Eye mask and TDP proposal to replace jitter bathtub

Piers Dawe
Agilent Technologies

Raleigh, NC, January 2002

BERT bathtub

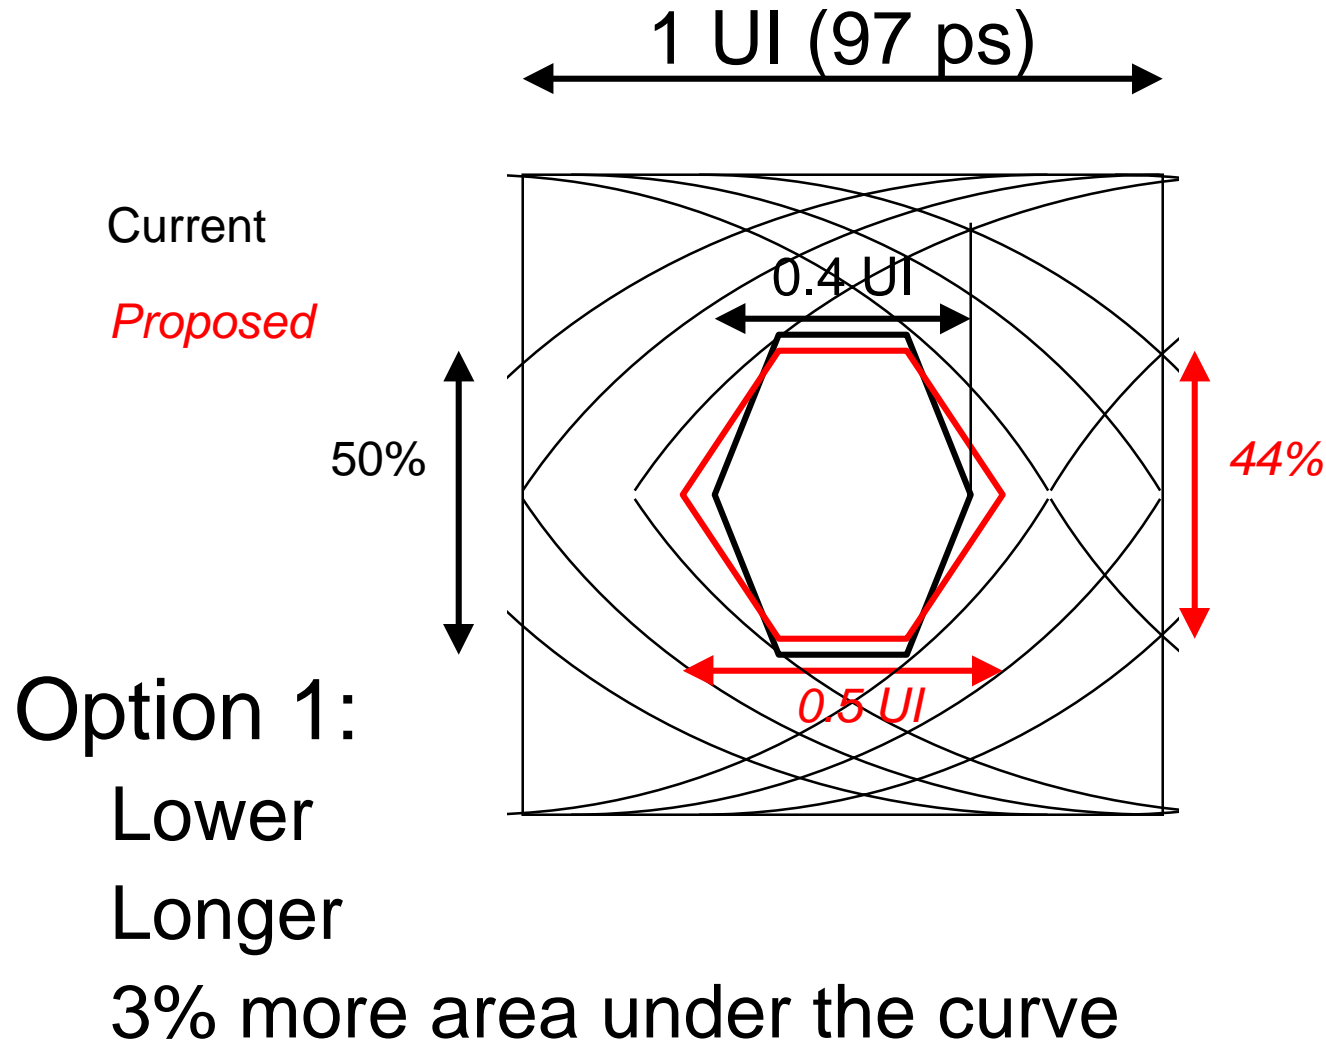
- BERT really measures low probability events (depending on the pattern)
- Good for diagnostics
 - Can separate W and sigma
- Technique has been tried in at least two labs and can be automated

- Test instrument data dependent jitter consumes a significant fraction of “W”
- DDJ cannot be calibrated out without very detailed edge-by-edge measurements
 - DDJ of DUT and apparatus is correlated: may add, subtract or anything in between
- Unknown errors --> extra margin needed in production test and/or design --> more \$\$\$
 - Slow measurement \$\$\$

Proposed mask Option 2

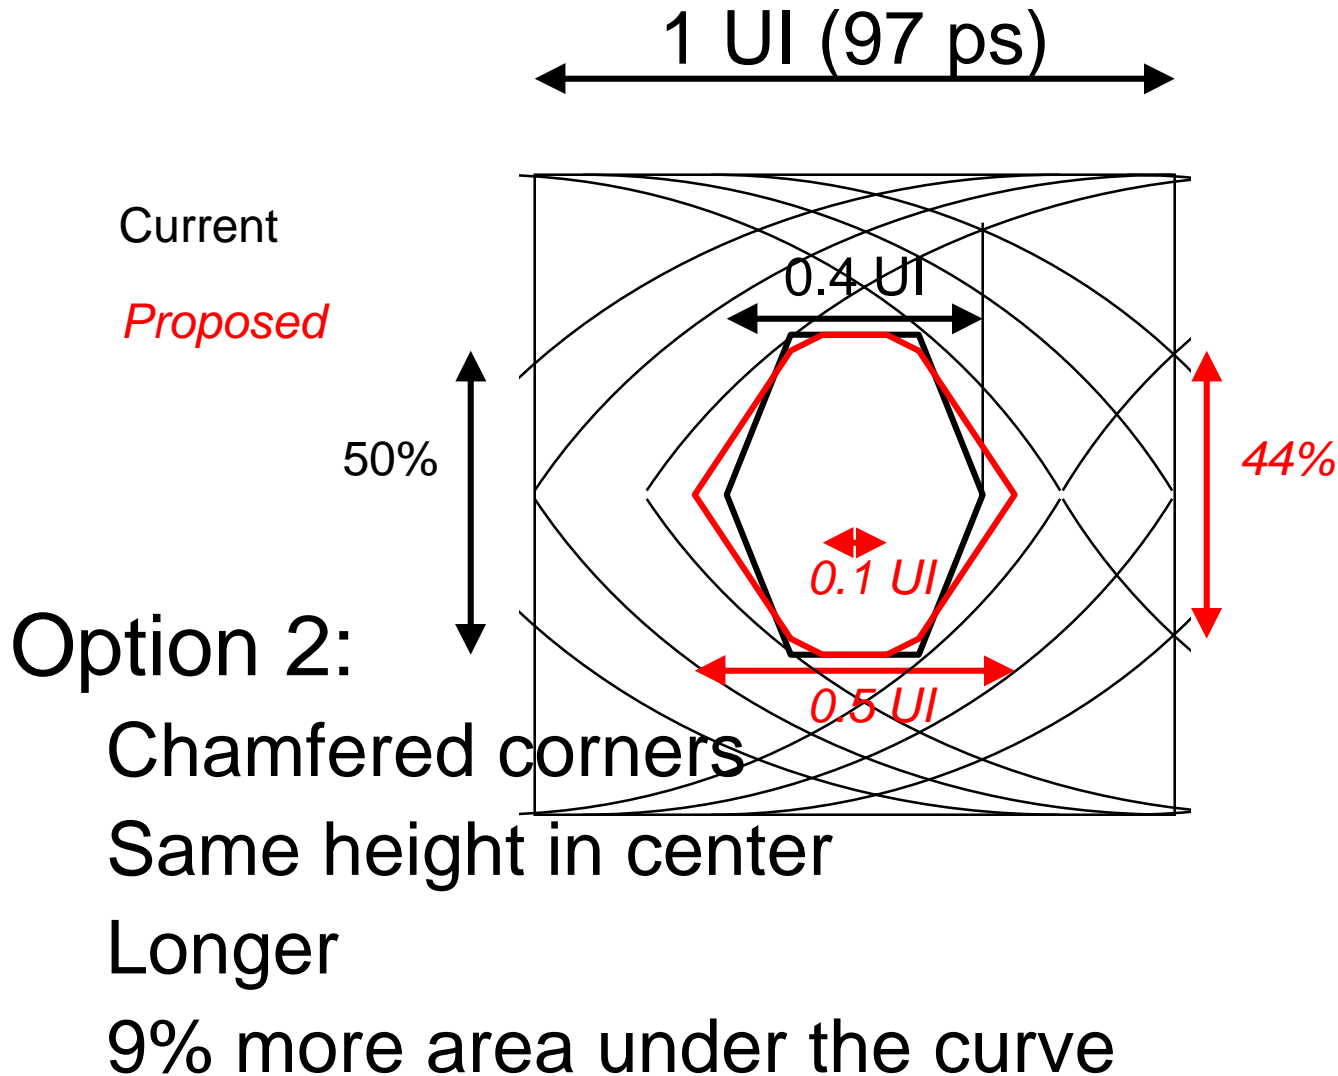
- Extend the hexagon idea: decagon *(see slide 7)*
- Extend mask from 0.4 to 0.5 UI long
 - Move four corners from 50% to 44% apart in y
 - Insert four new corners at $x=0.4, 0.6$
 $y=25\%, 75\%$ (50% apart; as previous corners)
 - Keep the mask fixed in center
 - For reasons of interoperability and simplicity
 - Benefits as Option 1, plus...
 - Maintains central vertical eye opening
 - Minimizes impact on receiver

Proposed mask Option 1

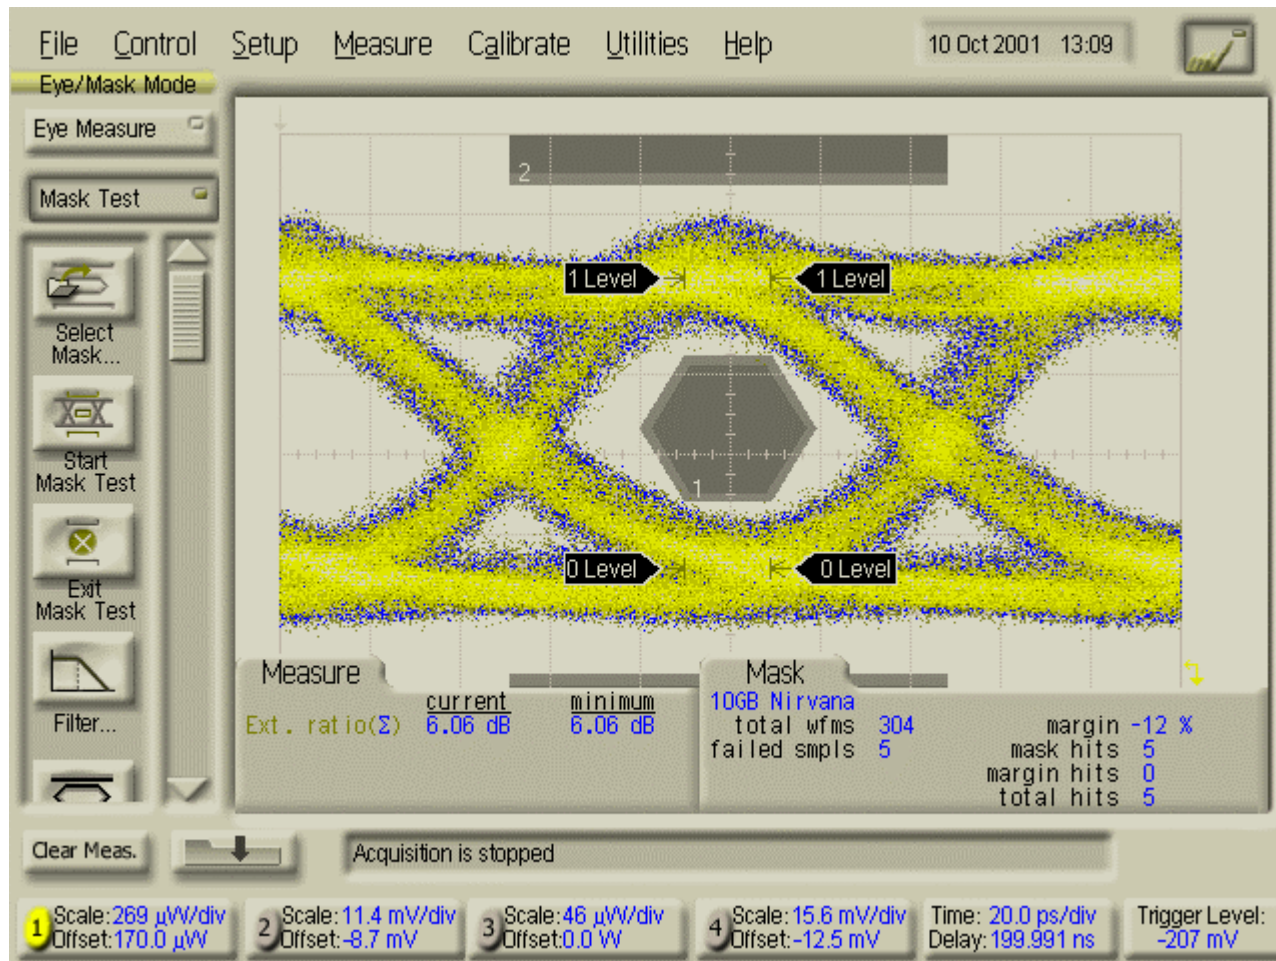
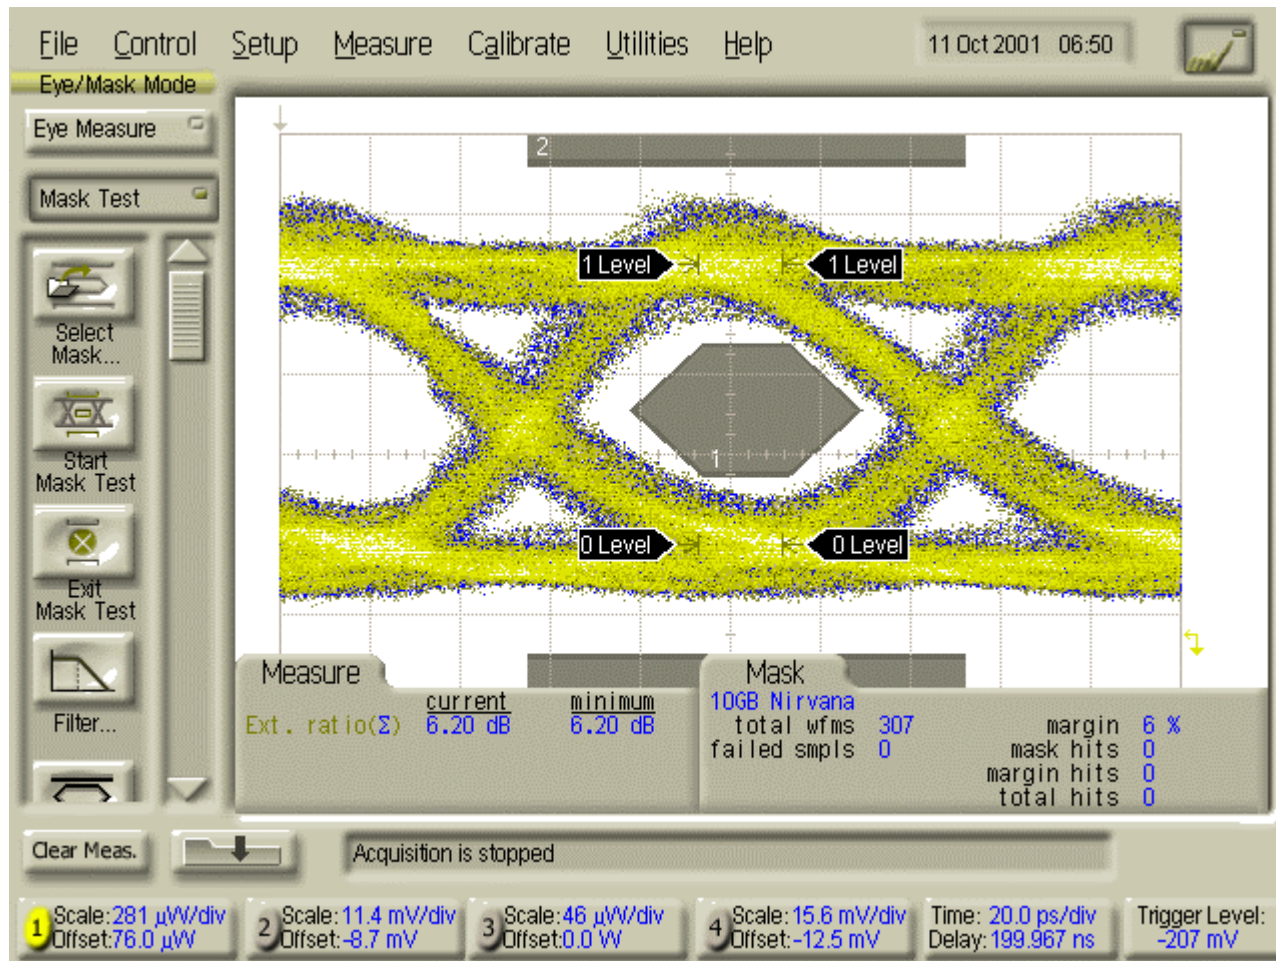
- Extend hexagon from 0.4 to 0.5 UI long
- Reduce height from 50% to 44%
- Keep the mask fixed in center
 - For reasons of interoperability and simplicity
- This change allows slower eyes
 - Reduced power drivers, ultimately cheaper
- The lengthened mask allows us to drop the jitter bathtub measurement
 - Maintains quality by forcing reasonable jitter
 - Immediately cheaper: quicker measurement
- TDP measurement protects vs. excessive eye closure even with a less high mask

Example: present eye

Example: proposed eye
